Exhibit A

File No. 230626

**1st Amendment to Detailed Planned Development known as Block 3 – Arena Master Plan (Phase 1)
1051 & 1047 N Vel R Phillips & 500 West State Street (formerly part of 1001 N. Vel R. Phillips Av.)
September 18, 2023**

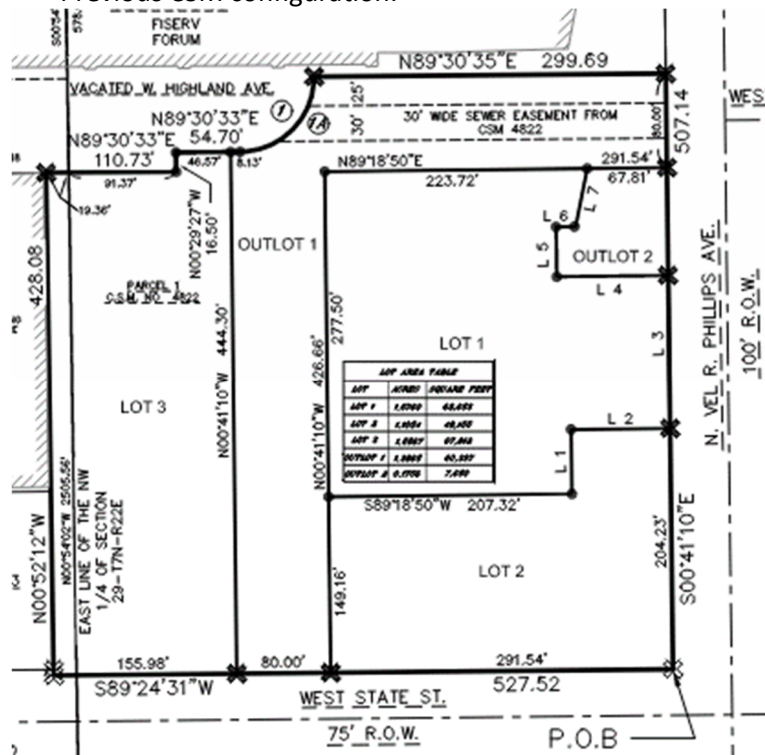
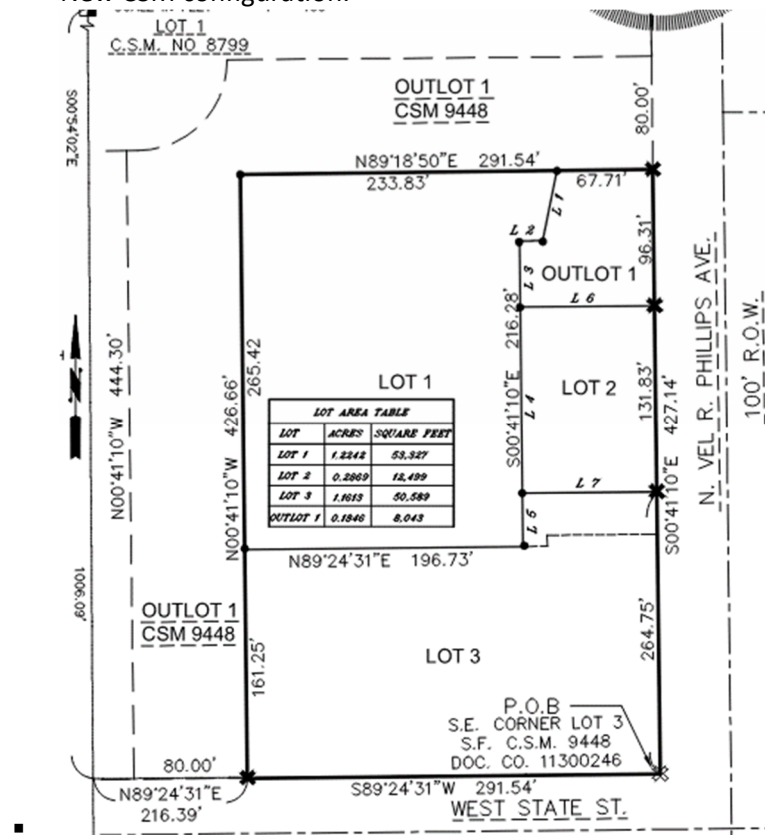
- A new CSM has been submitted to split the Lot 1 (1051 N Vel R Phillips) parcel and create a new lot (to be known as Lot 2) between the music venue and Vel R. Phillips Avenue for future development.

- The music venue parcel (1051 N Vel R Phillips) will continue to be known as Lot 1 of the CSM, and the Outlot (1047 N Vel R Phillips) northeast corner plaza of the site will now be known as Outlot 1.

- Because of the smaller footprint of the music venue, approximately 2,434 square feet of land within the DPD is no longer needed and will be shifted to the south parcel 430 West State Street (Lot 3), which is zoned General Planned Development (GPD; Arena Master Plan).

- The new CSM submitted, in conjunction with this amendment request, created a need to clarify the Lot and Outlot names and addresses as follows for this amendment:

- Lot 1 - 1051 N Vel R Phillips remains as the music venue parcel; remains in the DPD. Approx. 2,434 sf of land from this lot will shift to Lot 3
 - Lot 3 - 430 West State Street (formerly Lot 2) – remains zoned GPD and gets slightly larger

- Lot 2 (future development site)– Requires new address to be assigned (formerly the east portion of Lot 1); remains in DPD
 - Service/Plaza Outlot - 500 West State Street (service drive and north plaza that were formerly labeled as Outlot 1 in the original CSM and DPD exhibits); remains in DPD

- Outlot 1 (east plaza) - 1047 N Vel R Phillips (formerly labeled as Outlot 2 in the original CSM and DPD exhibits); remains in DPD
